OVERVIEW	CLUTCH KIT	COVER ASSEMBLY	DRIVEN PLATE	RELEASE BEARING

RELEASE BEARING CARRIER

DIFFICULT GEAR ENGAGEMENT

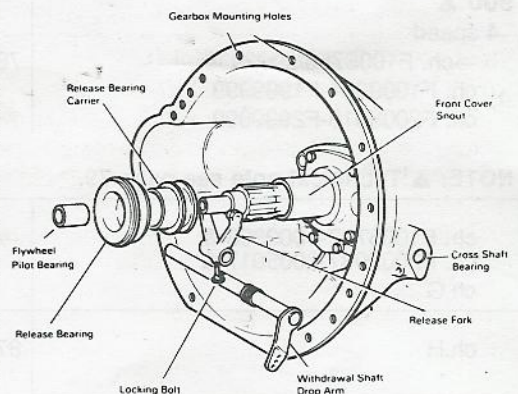
To reduce the friction of the release bearing carrier during clutch operation, a new carrier was introduced by Triumph in November, 1975 for the above vehicles. At the same time the snout on the gearbox front end cover was extended to improve the support of the carrier in the clutch fully released position. Your attention is drawn to this change as there appears to be some confusion as to the reason for 'notchy' clutch withdrawal action and its cure.

The new carrier (or throw out sleeve) Triumph pt. no. 154976, is identified by a machined out portion in the centre of the bore.

The new front end cover, Triumph pt. no. 154975, has an overall length to the end of the snout of 4.25" (108 mm.) against the old condition of 3.22" (82 mm.).

Note that the new parts must be fitted in sets and should not be interchanged as separate items to the early condition.
